The following changes in the tender documents are effective immediately. This addendum will form part of the contract documents.

**END OF ADDENDUM No. 2**

**WILLIAM HEAD INSTITUTION ELECTRICAL HIGH VOLTAGE UPGRADE (PHASE 2 OF 2)**

Drawing title/Titre du dessin  
**OUTDOOR ENCLOSURE TR6**

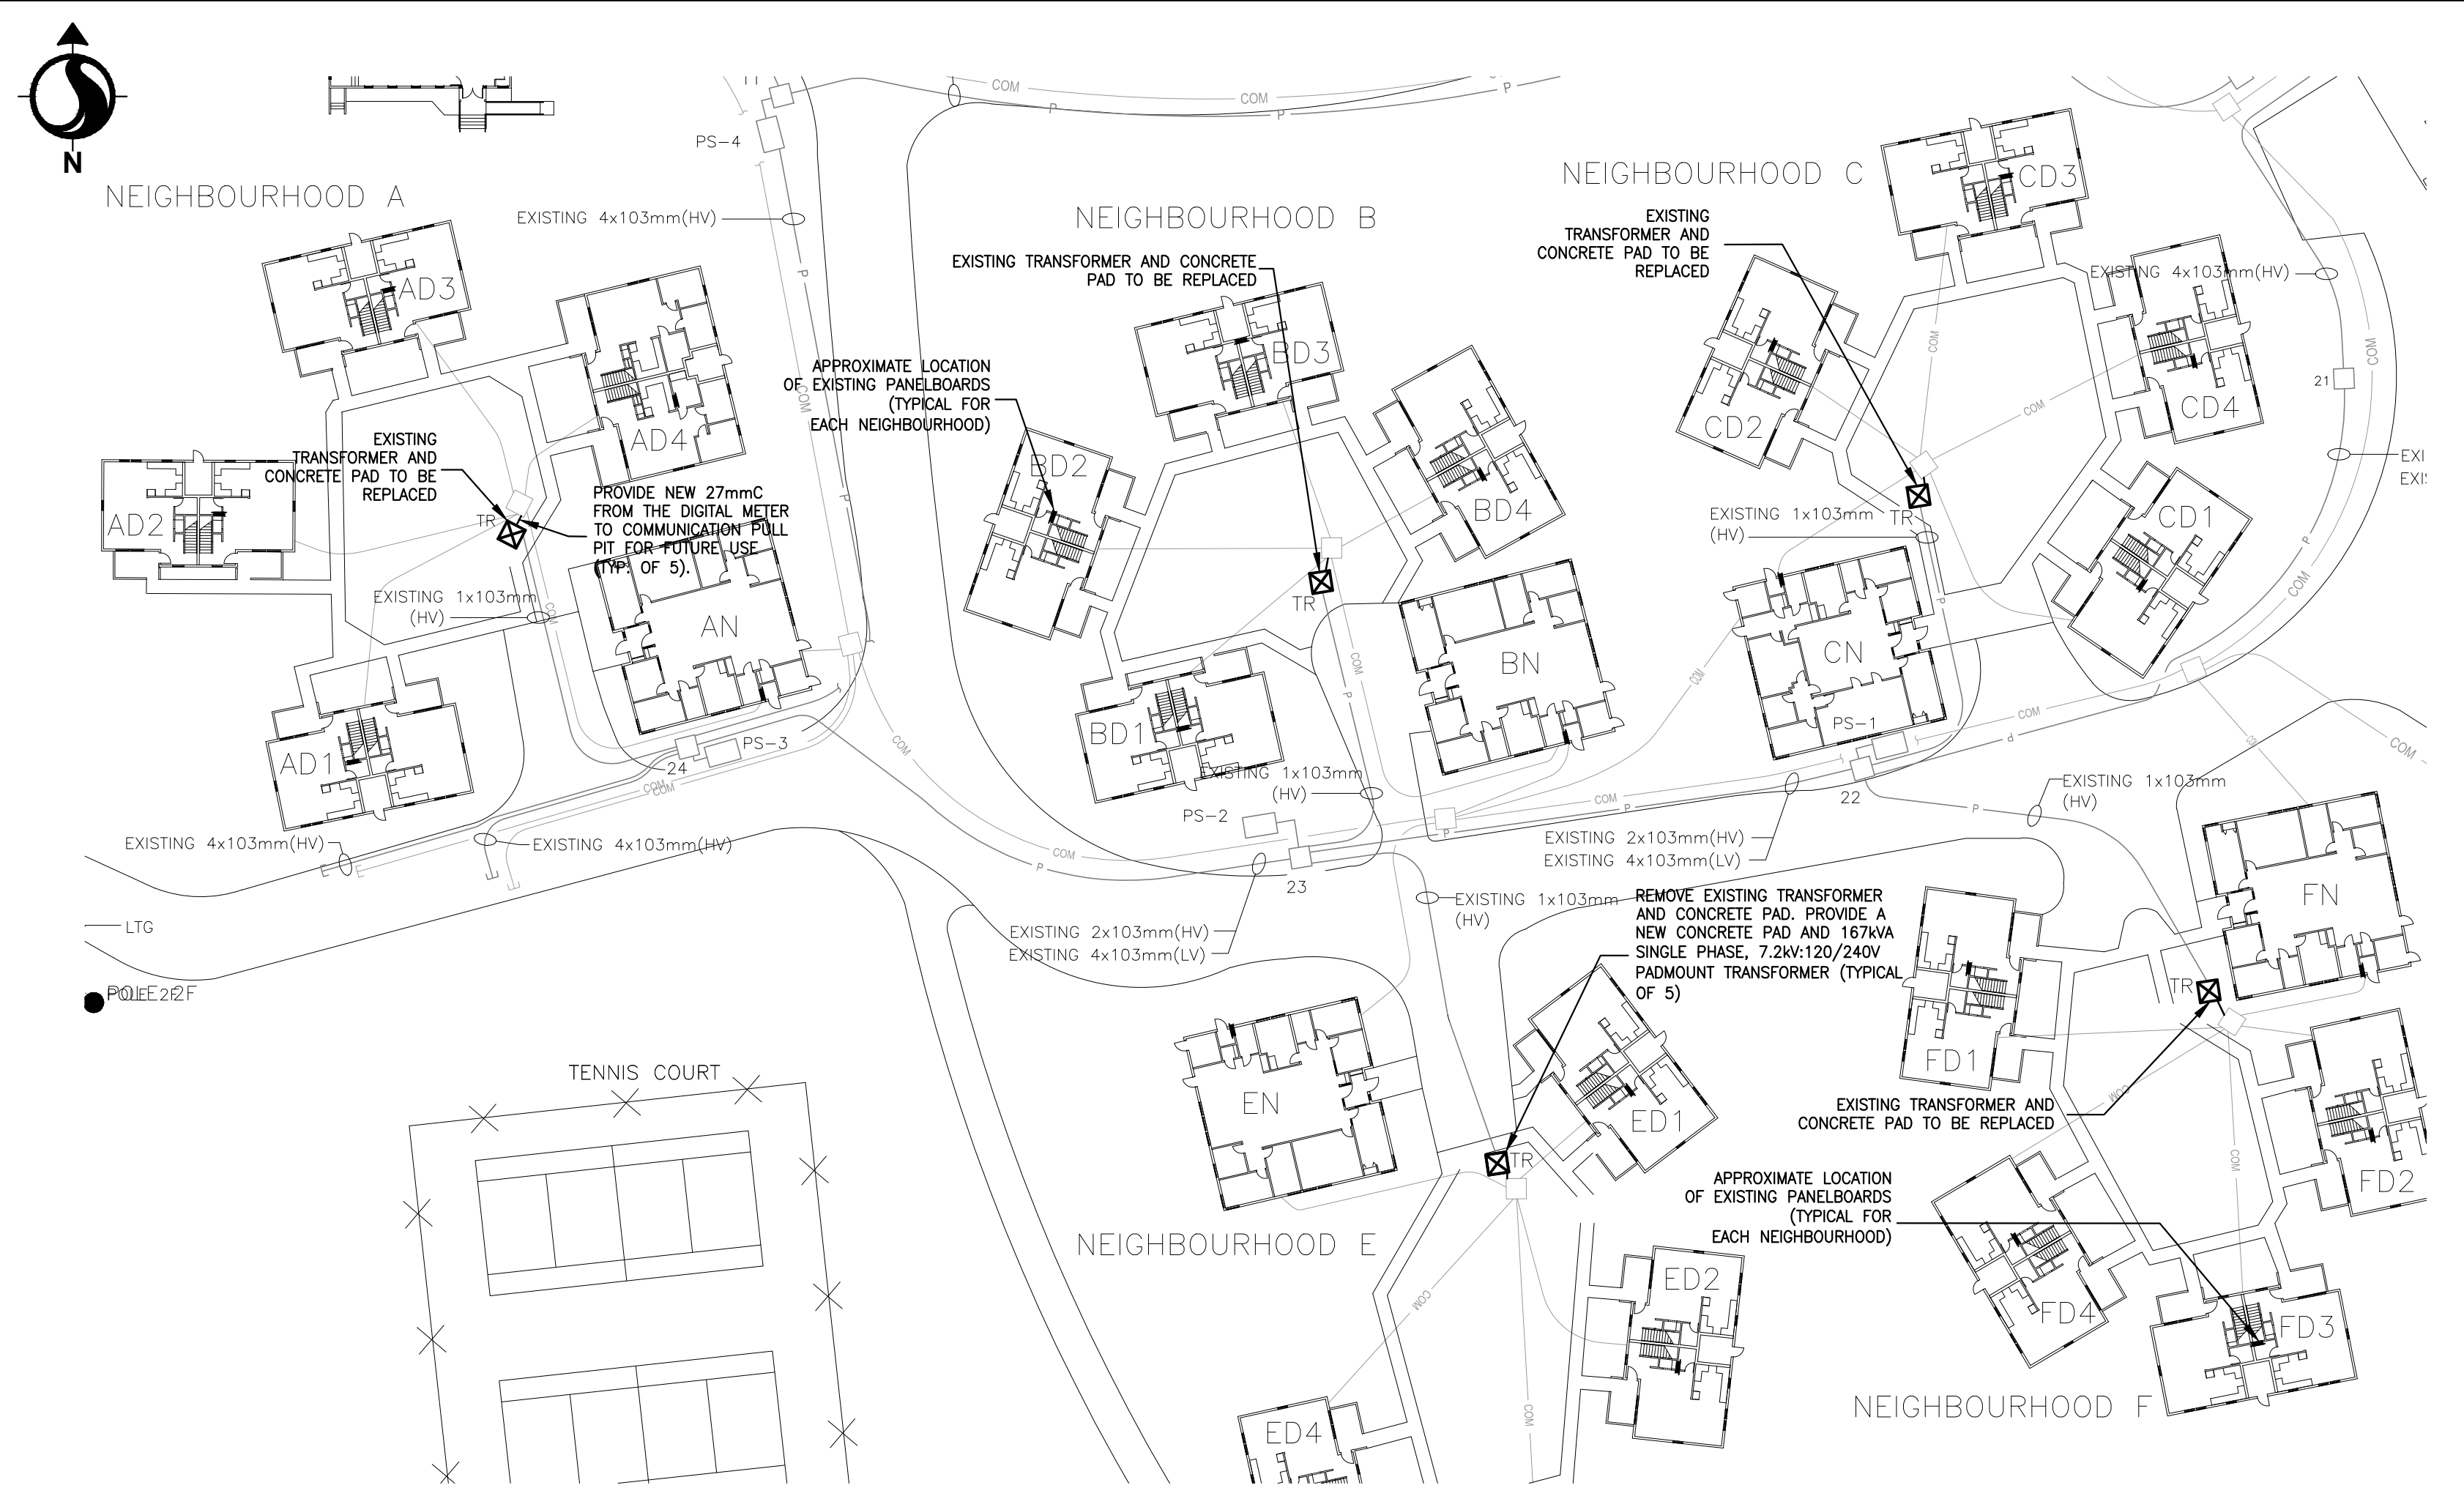
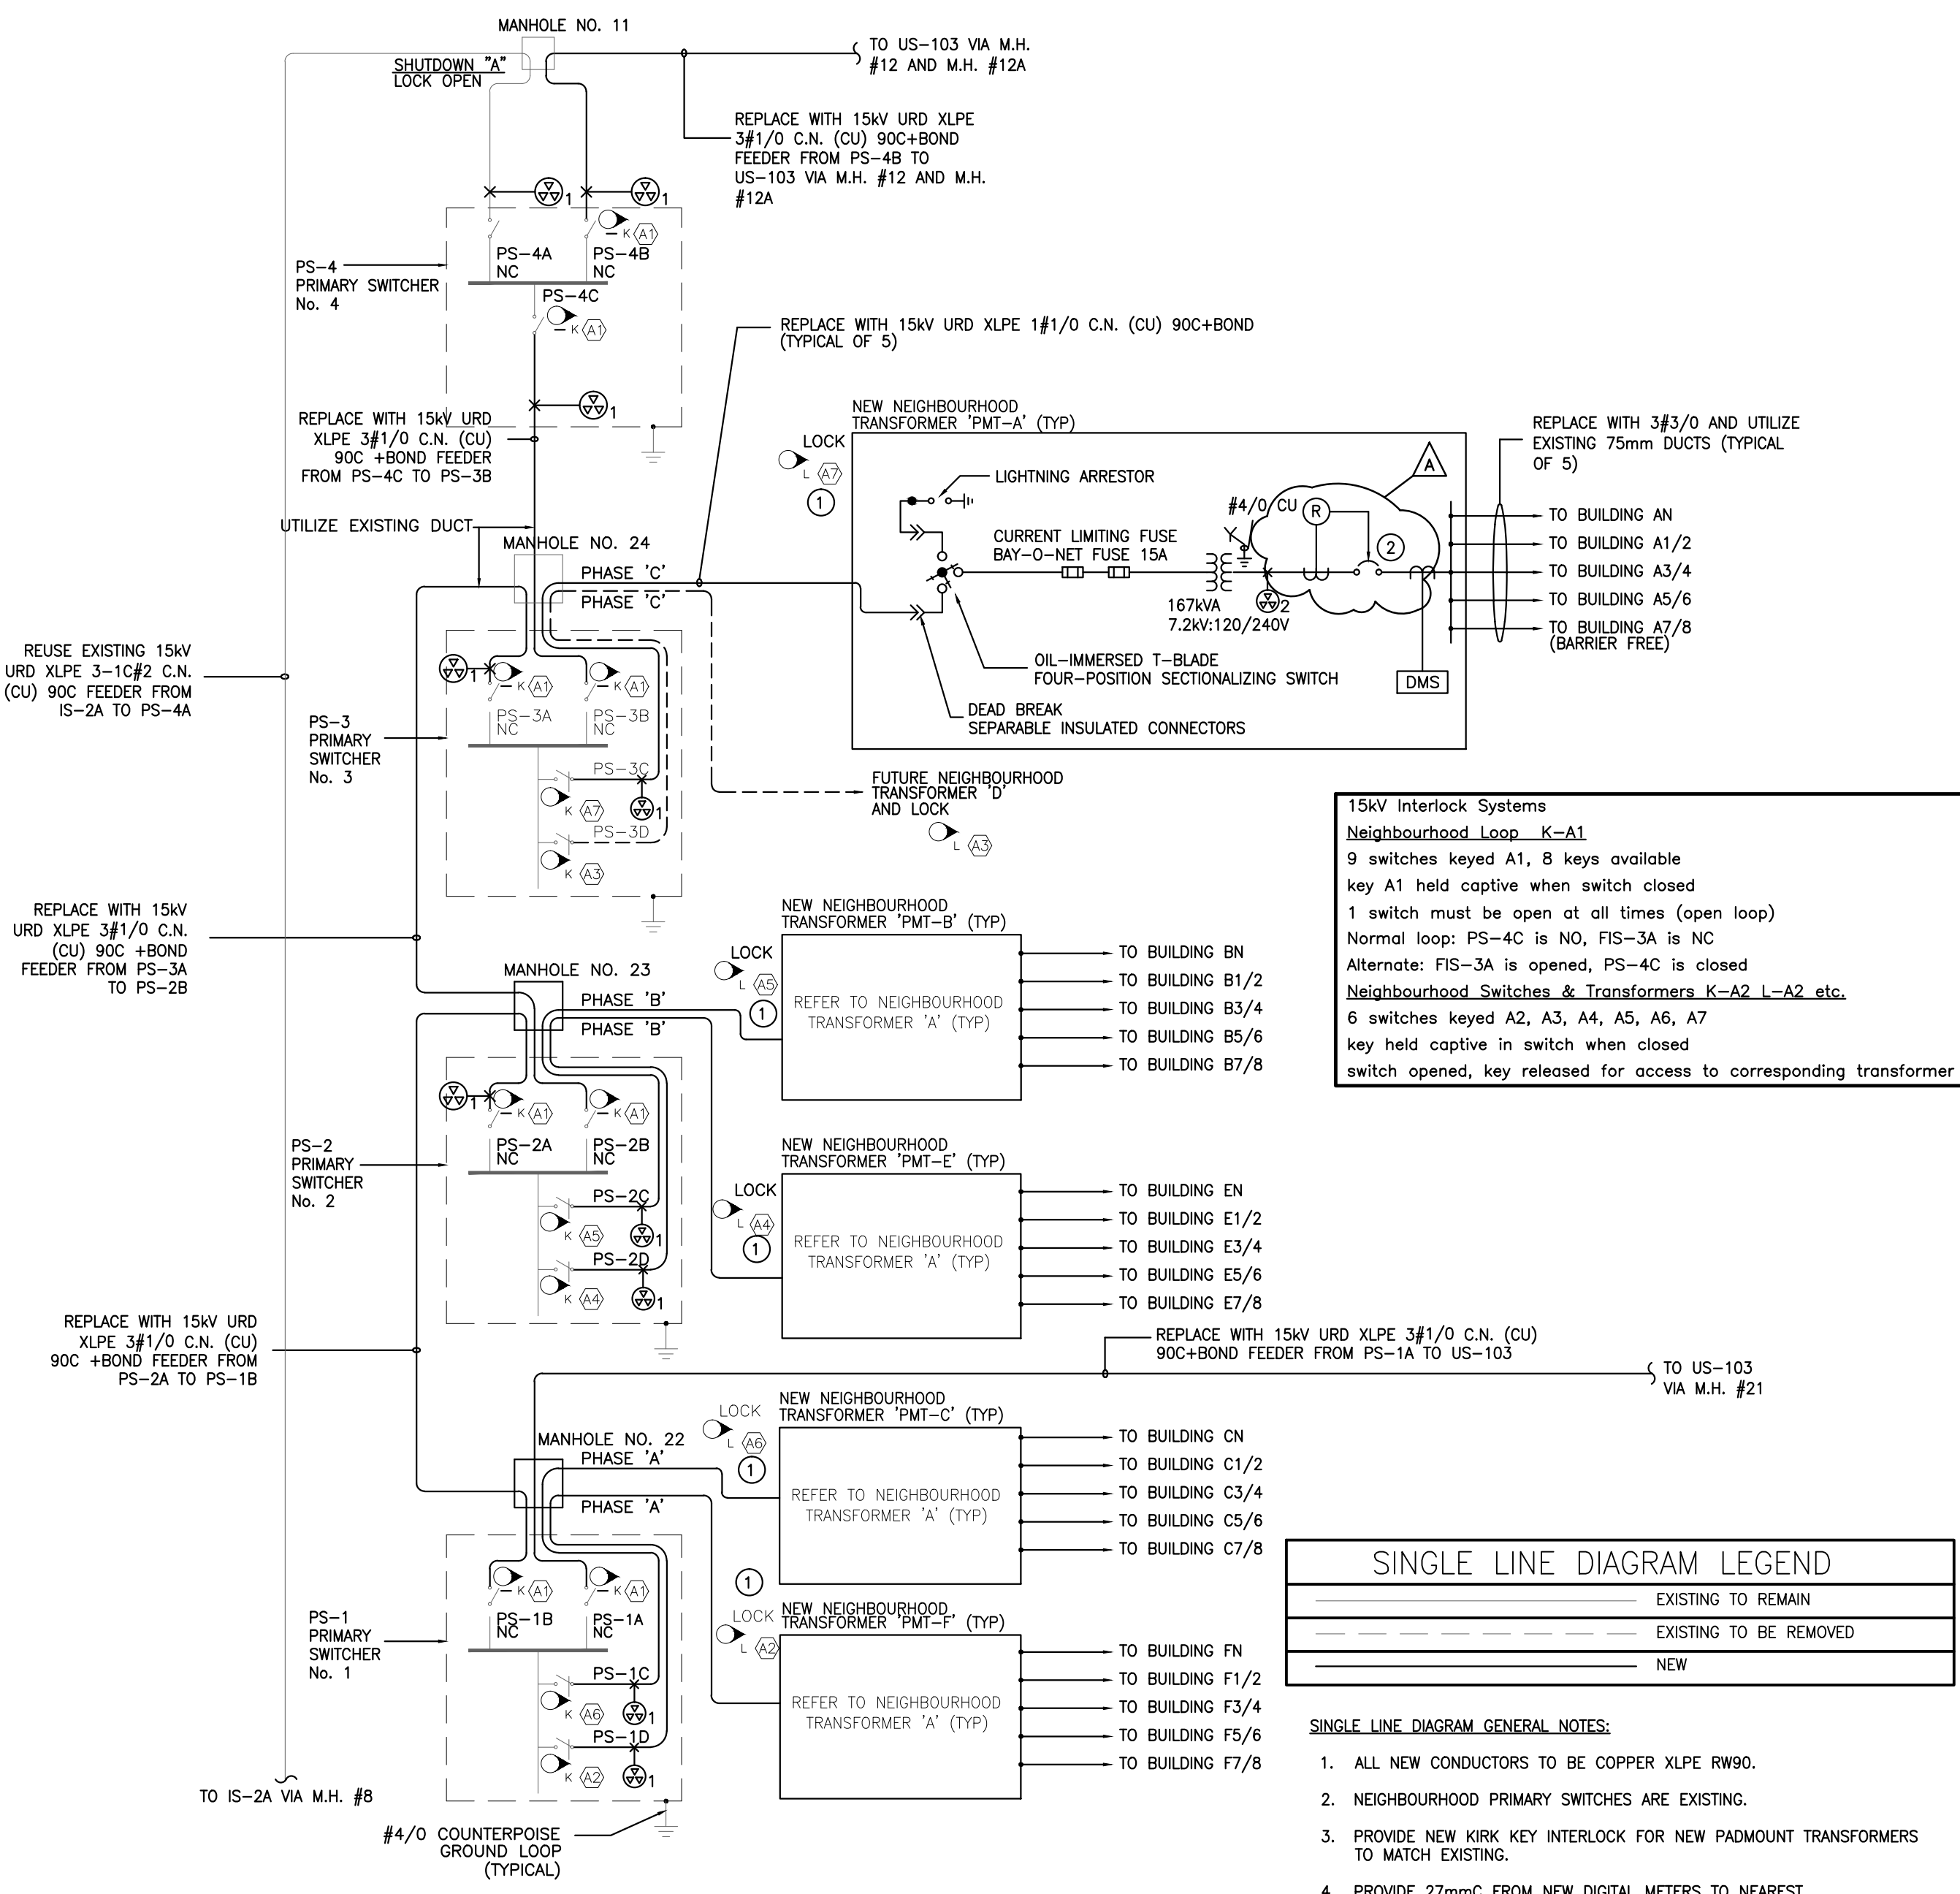
1. Clarify that communications conduit is to be concrete encased.

Drawing title/Titre du dessin  
**NEIGHBOURHOODS 'A', 'B', 'C', 'E', 'F'**

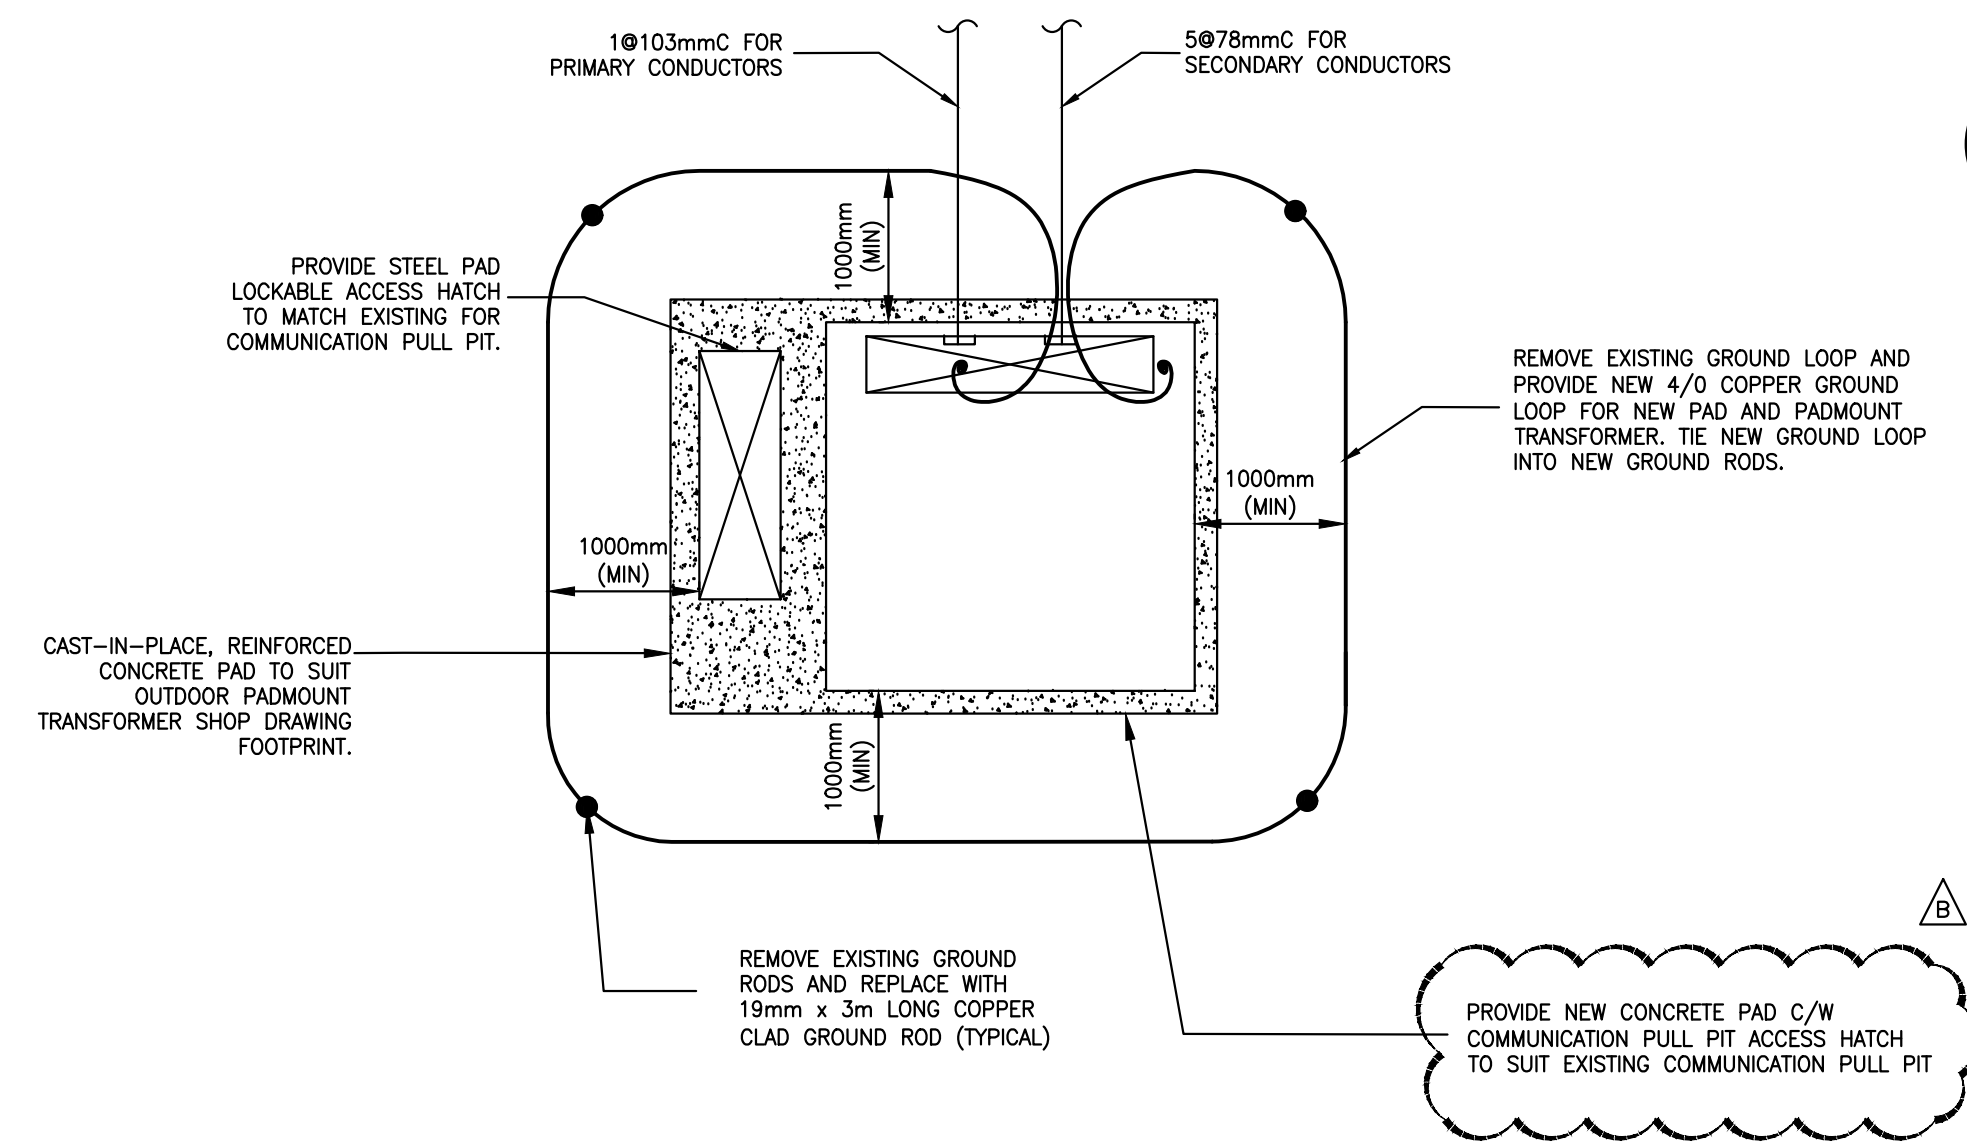
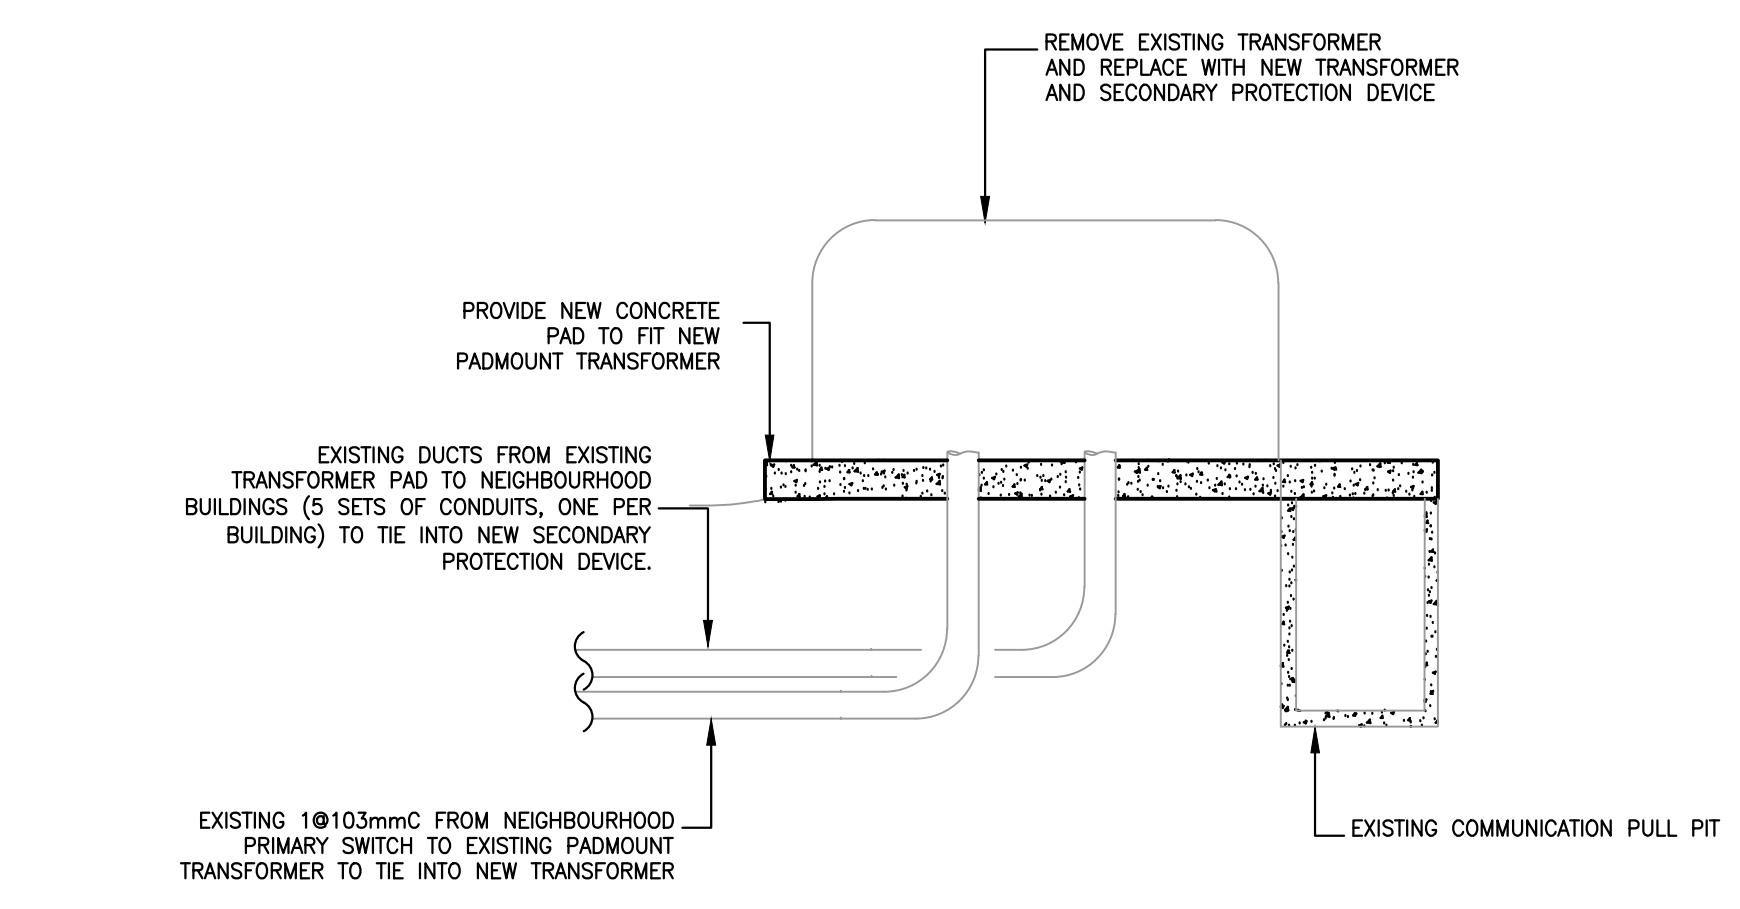
1. Revise reference note on grounding detail as noted
